[Docket No. 98-SW-24-AD; Amendment 39-10989; AD 98-12-30]

Airworthiness Directives; McDonnell Douglas Helicopter Systems Model MD-900 Helicopters

ACTION: Final rule; request for comments.

Figure 1. Main Rotor Upper Hub Assembly Inspection.

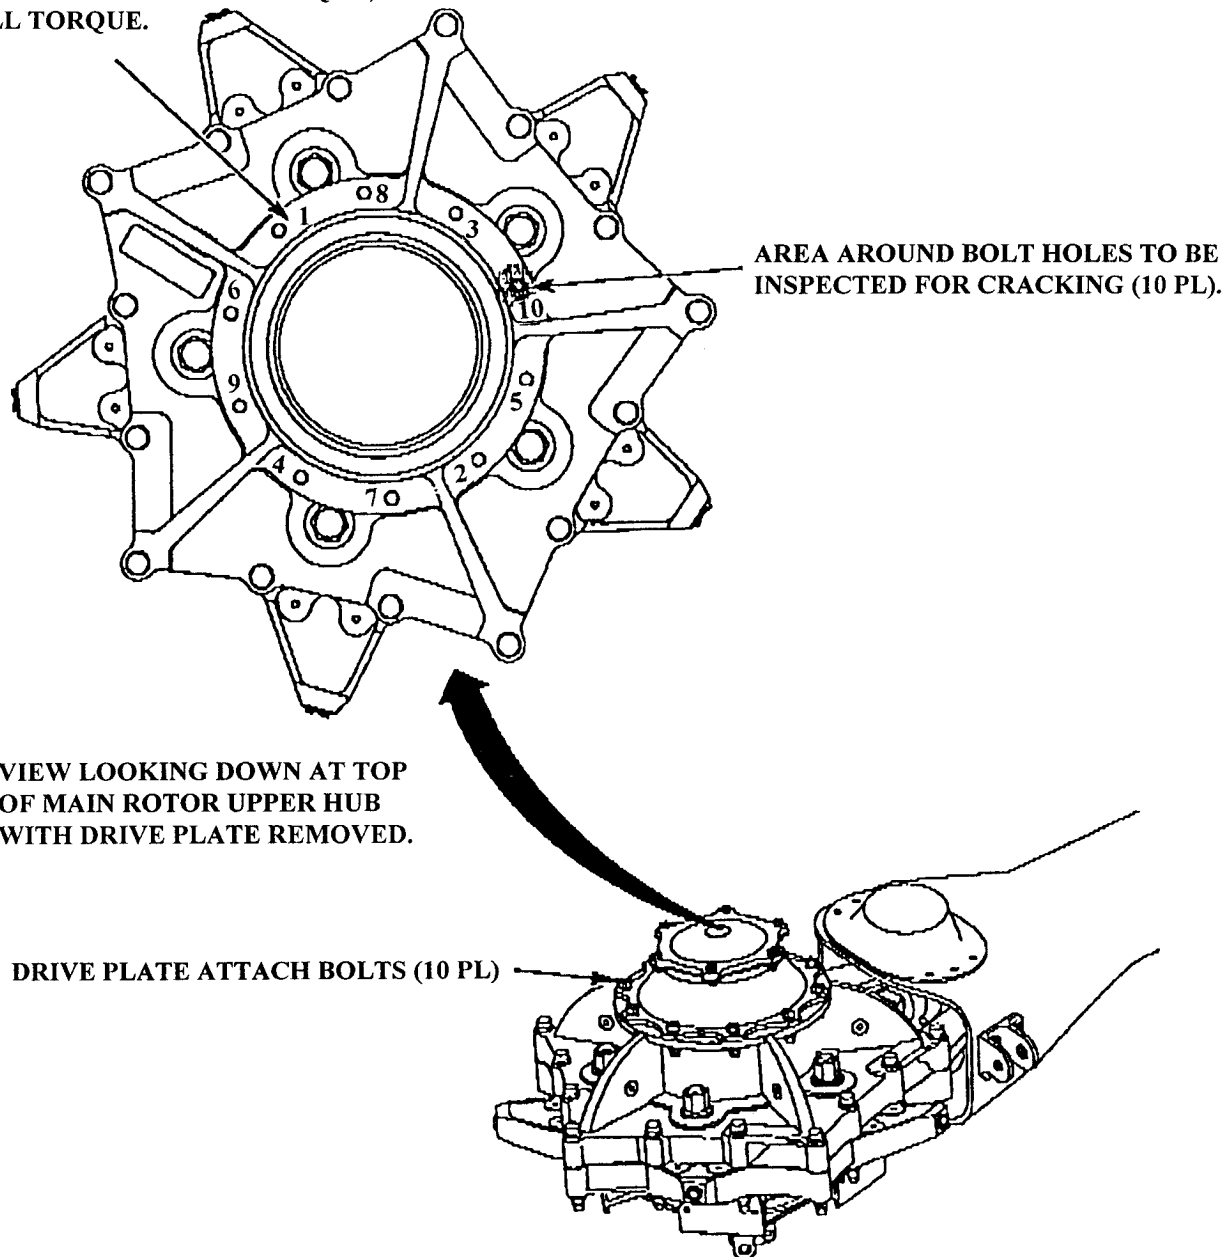
(2) Using an indelible marker, number the main rotor drive plate attachment fastener torque sequence on the drive plate (Figure 1).

(4) Using paint stripper (C313 or equivalent) and cleaning solvent (C420 or equivalent), remove the paint from the upper mating surface of the hub assembly to enable an accurate visual inspection of the drive plate attachment bolt hole (bolt hole) area for cracking (Figure 1). Ensure the paint stripper and solvent DO NOT contaminate the upper bearing and upper grease seal areas.

(7) Reinstall the main rotor drive plate using 10 new sets of replacement attachment hardware. Torque the nuts to 160-180 in.-lbs. above locknut locking/run-on torque in the sequence shown (Figure 1). Record in the rotorcraft log book the locknut locking/run-on torque for each nut.

1. MAIN ROTOR DRIVE PLATE ATTACHMENT
HARDWARE TORQUE SEQUENCE.
2. NUMBERING MAY START AT ANY HOLE.
3. TORQUE NUTS TO 1/2 TOTAL TORQUE,
THEN FULL TORQUE.
